EVANS  
TAYLOR  
FOSTER  
CHILDRESS  
ARCHITECTS  
343 North Main Street  
Memphis TN 38103

**ADDENDUM NO. 3**  
**March 8, 2024**

**FIRE STATION # 1**  
**City of Marion**  
**Marion, AR 72364**

A2.1

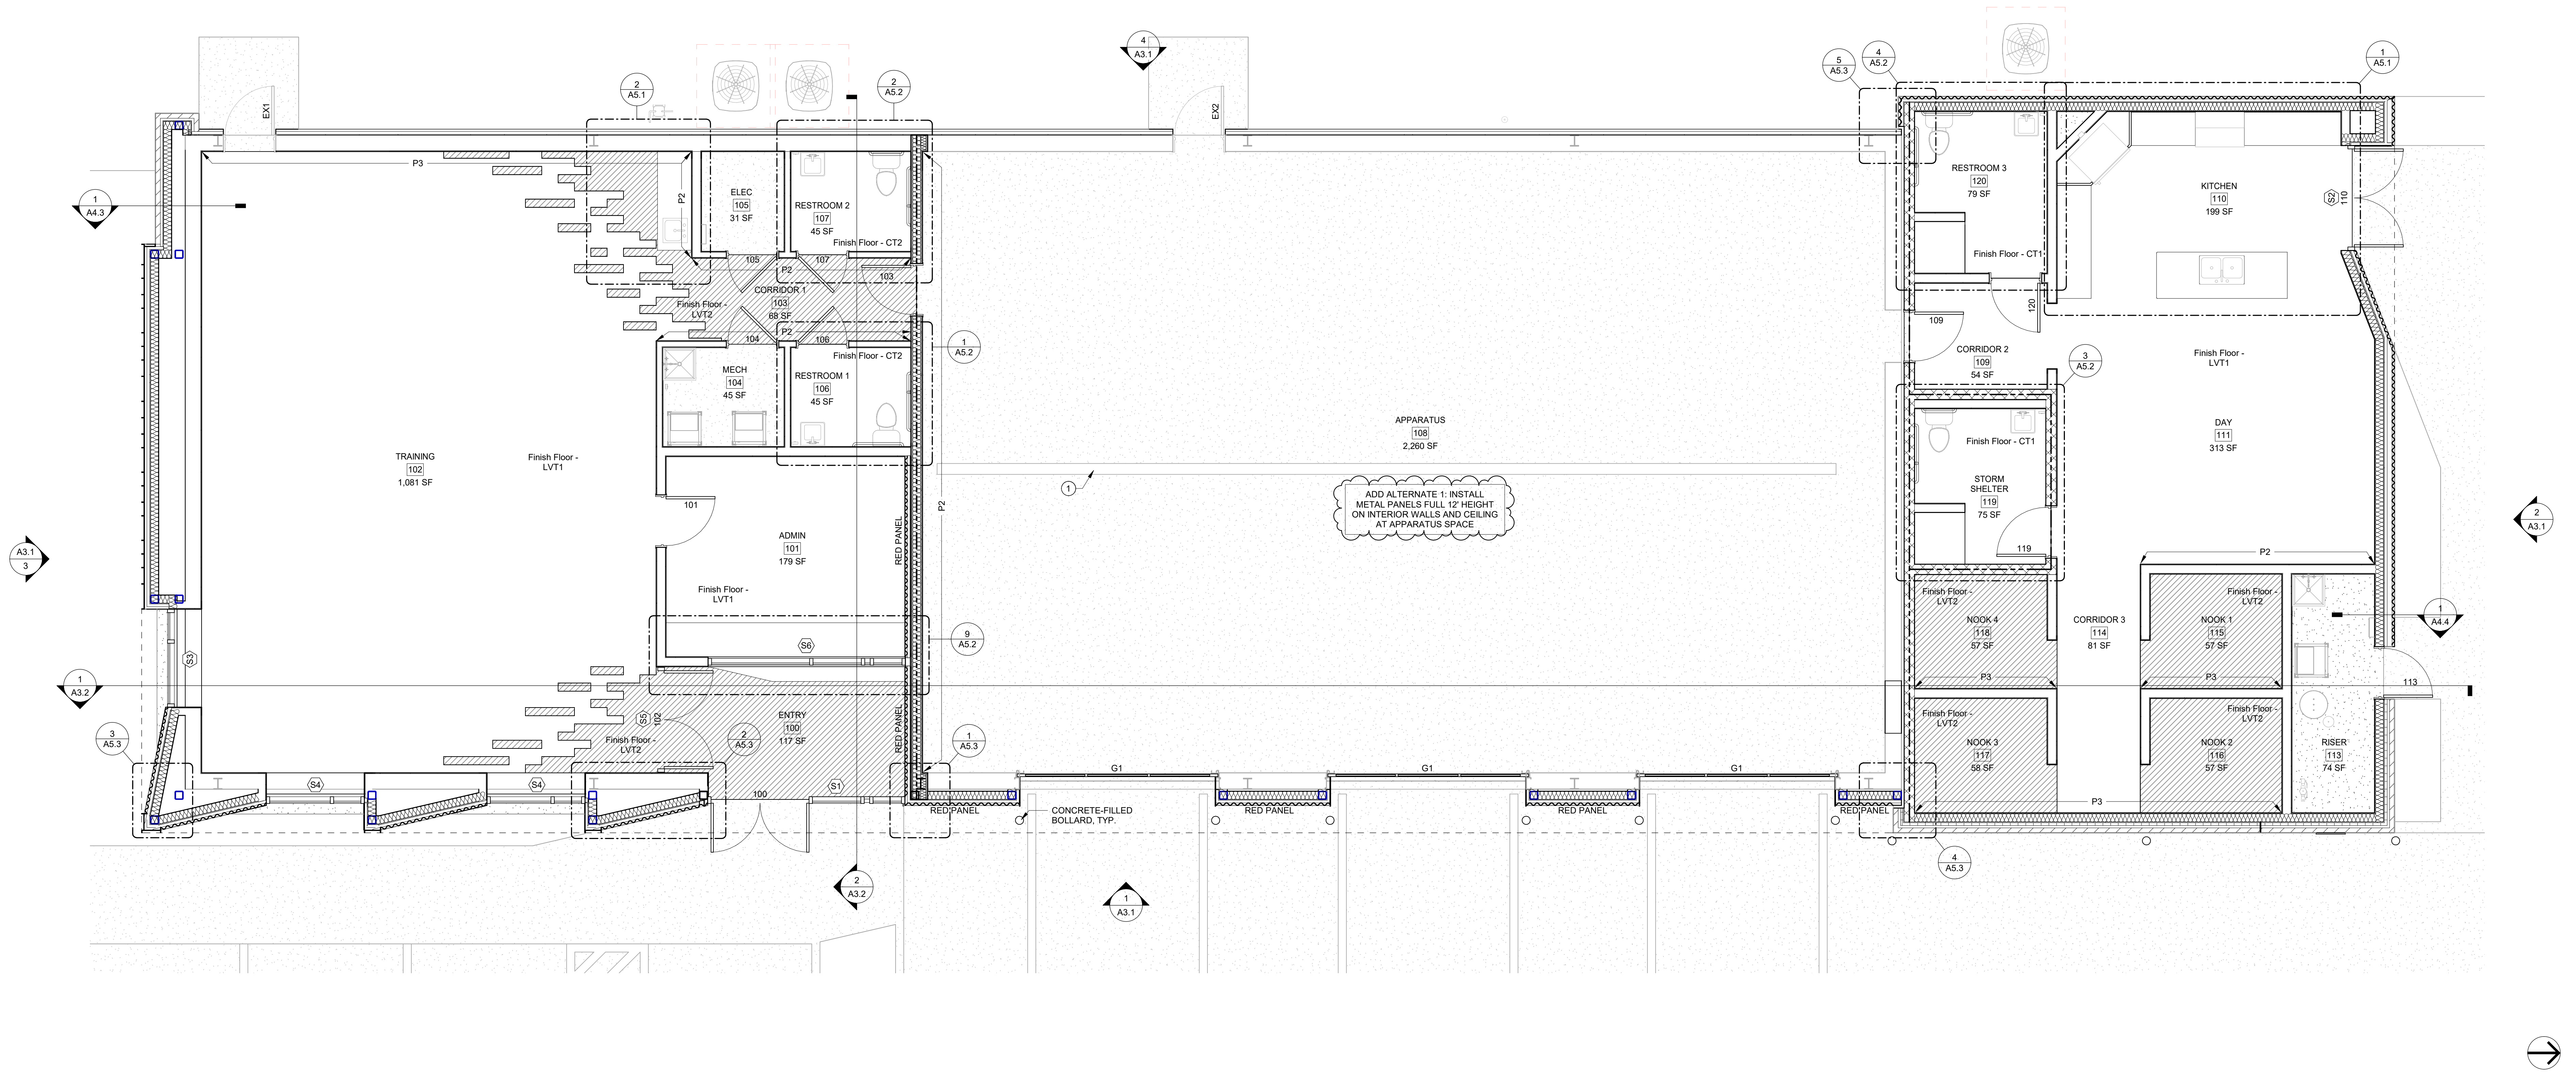
Reference Drawings, sheet A2.1, SP-2 panel; The SP-2 panels not labeled "Red Panel" shall be the standard medium gray.

A2.1 Revised "Add Alternate 1" Note.

**A2.3**

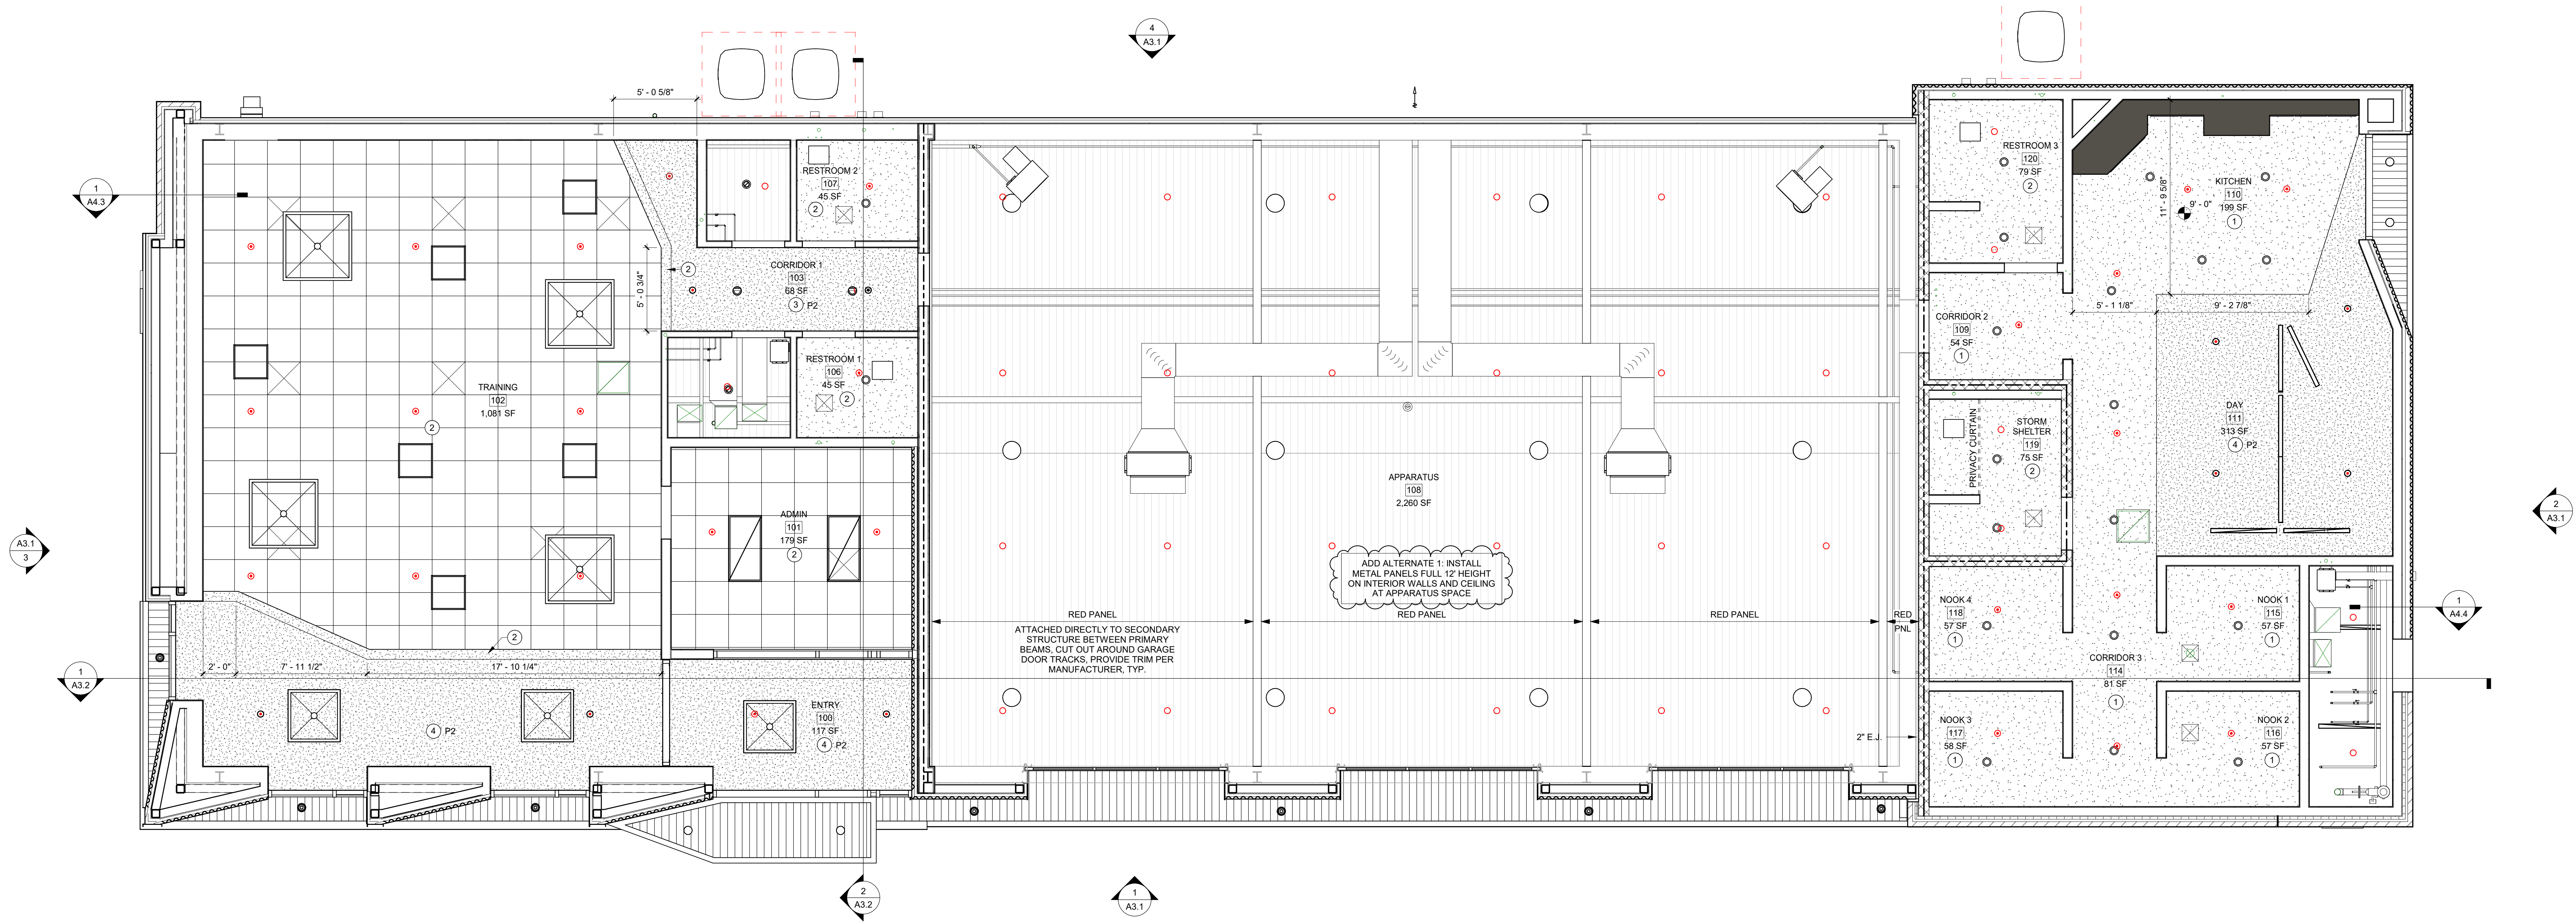
A2.3 Revised "Add Alternate 1" Note.

Drawing Number:  
**A4.2**  
Date: September 29, 2023 Project Number: 22207

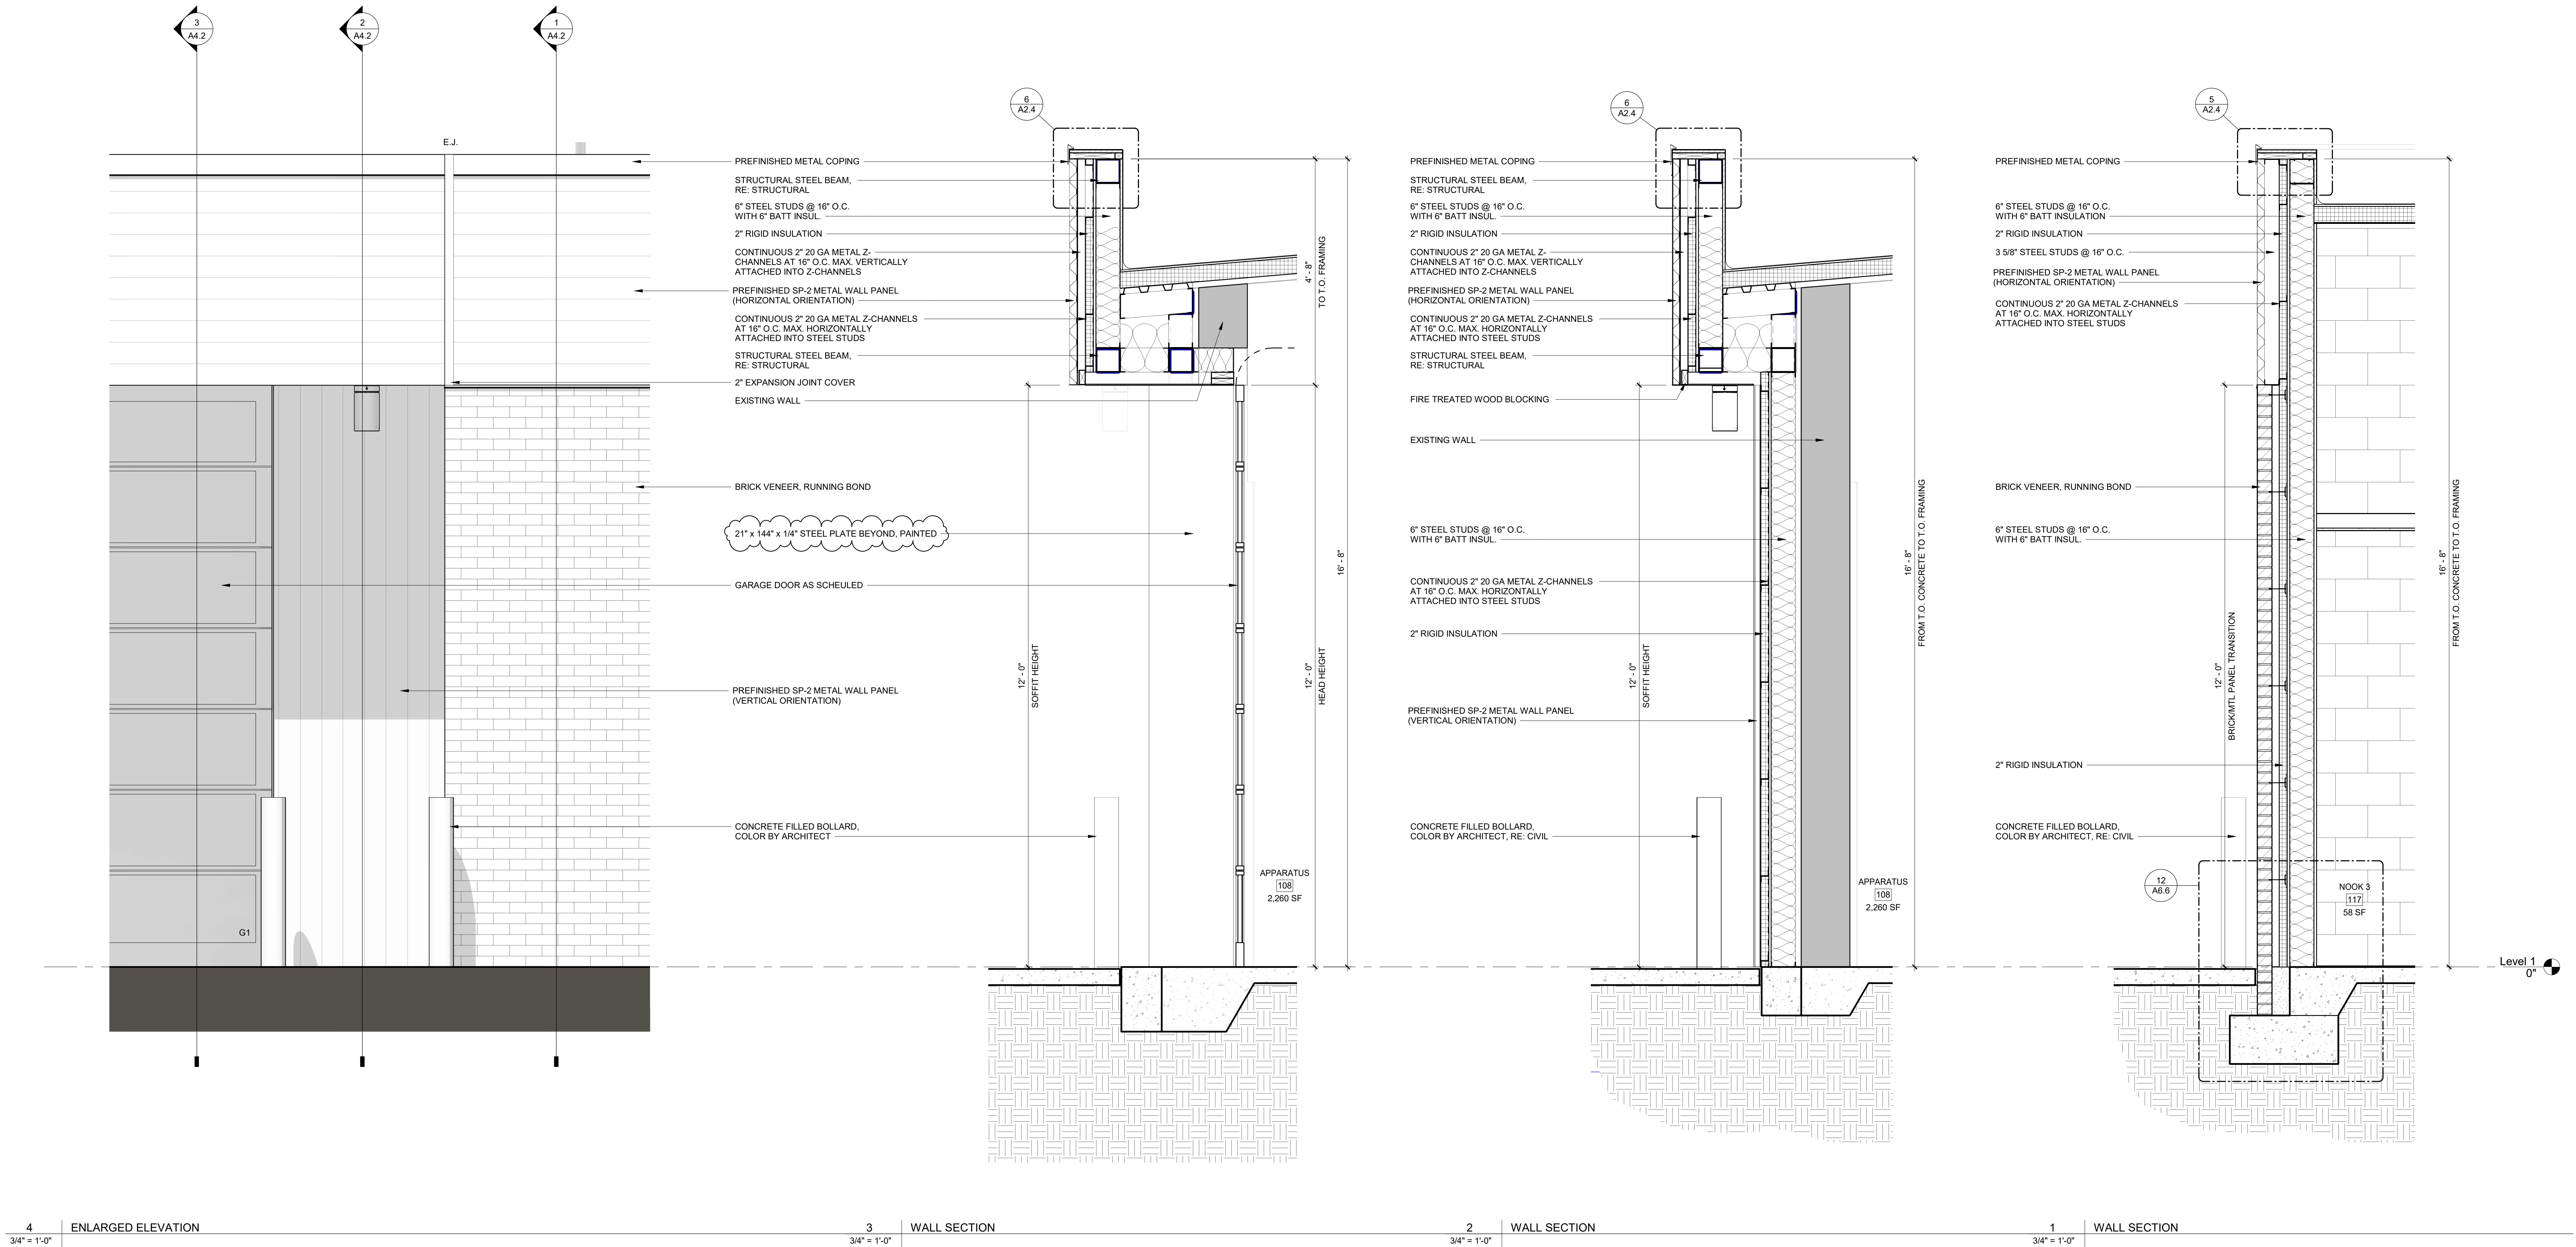
A4.2 Added steel plate note with dimensions for clarification at garage door locations.
